# METROPOLITAN GOVERNMENT OF NASHVILLE AND DAVIDSON COUNTY

## STAFF RECOMMENDATION 1408 Lillian Street June 17, 2015

**Application:** New construction-infill; Relocation; Setback determination  
**District:** Lockeland Springs-East End Neighborhood Conservation Zoning Overlay  
**Council District:** 06  
**Map and Parcel Number:** 08313032500  
**Applicant:** Cathedral Homes  
**Project Lead:** Melissa Baldock, melissa.baldock@nashville.gov

FRONT ELEVATION

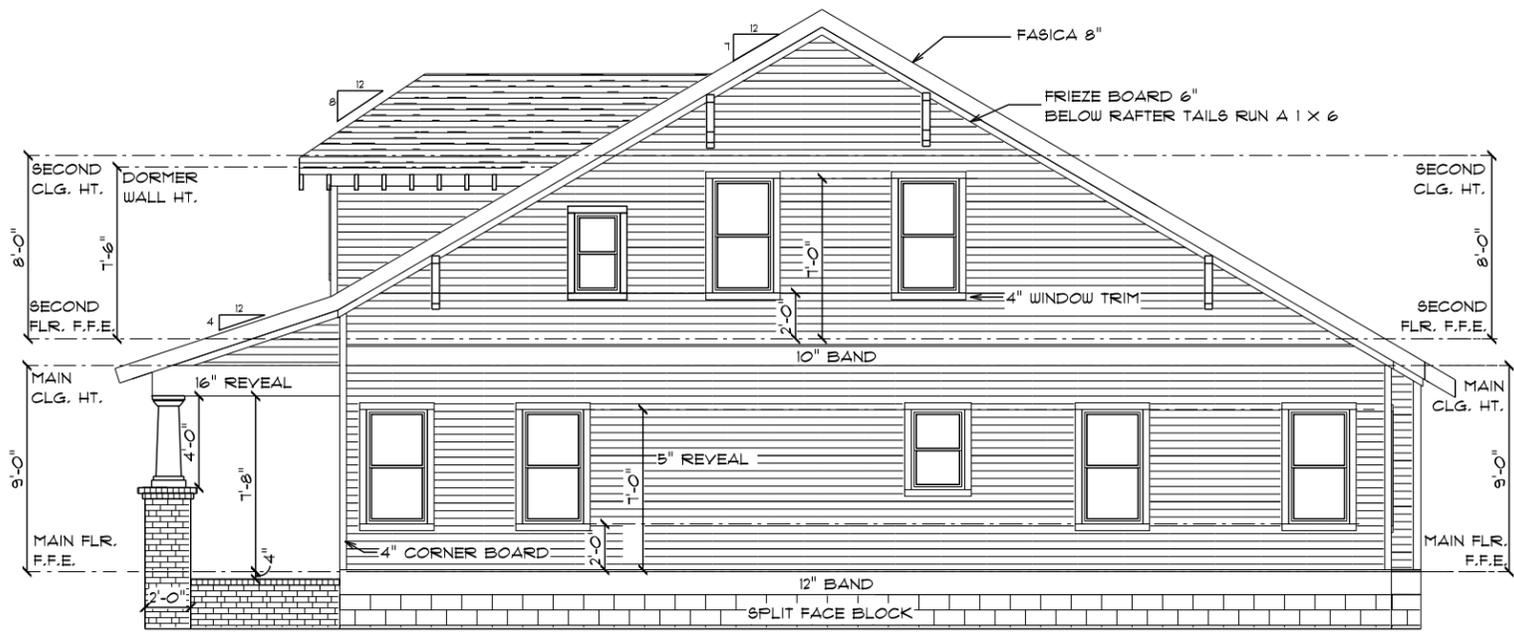
Roof form: The roof is typical for a bungalow. It is a side gable with a slope of approximately 6/12. On the front, a centered dormer has a hipped roof with a slope of 7/12. The drawings show that the dormer is not set back from the front wall of the house, and staff asks that the dormer be set back two feet (2') from the front wall of the house. The front porch will have a shed roof with a 4/12 pitch. With the condition that the dormer be set back two feet (2') from the wall below, staff finds that the infill's roof forms meet Section II.B.5. of the design guidelines.

1. The finished floor height be consistent with the finished floor heights of the adjacent houses, to be verified by MHZC staff in the field;
2. The applicant submit revised floor plans reflecting the window pattern of the side elevation drawings;
3. Staff approve the final details, dimensions and materials of windows and doors prior to purchase and installation;
4. Staff approve the roof color and masonry color, dimensions and texture;
5. The front dormer be set back two feet from the wall below;

**RIGHT ELEVATION**

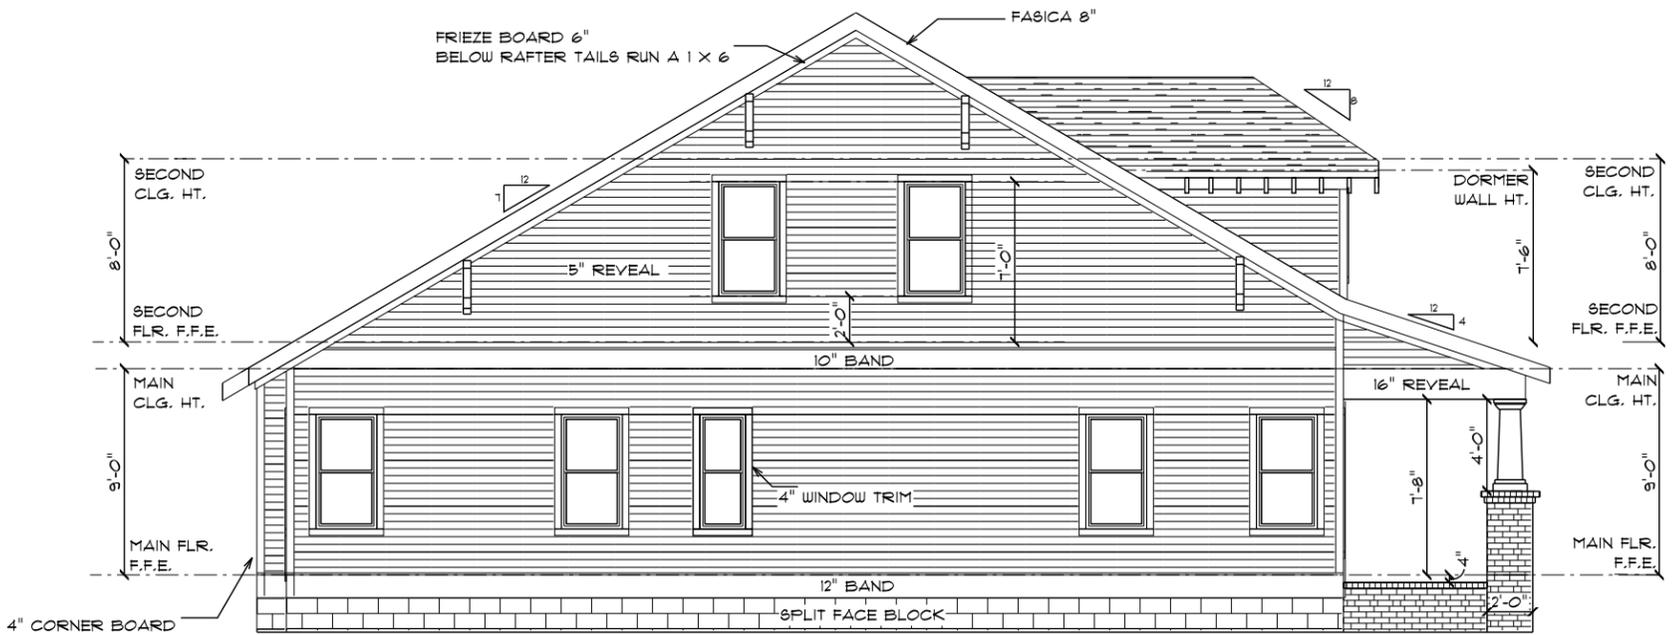
**Proportion and Rhythm of Openings:** The windows on the proposed infill are all generally twice as tall as they are wide, thereby meeting the historic proportions of openings. There are no large expanses of wall space without a window or door opening. Double and triple windows will have a four to six inch (4"-6") mullion between them. The floor plans that were submitted do not show the window pattern that is shown on the side elevation drawings. Staff recommends that the applicant submit revised floor plans to reflect the window pattern shown on the side elevations. Staff finds the project's proportion and rhythm of openings to meet Section II.B.7. of the design guidelines.
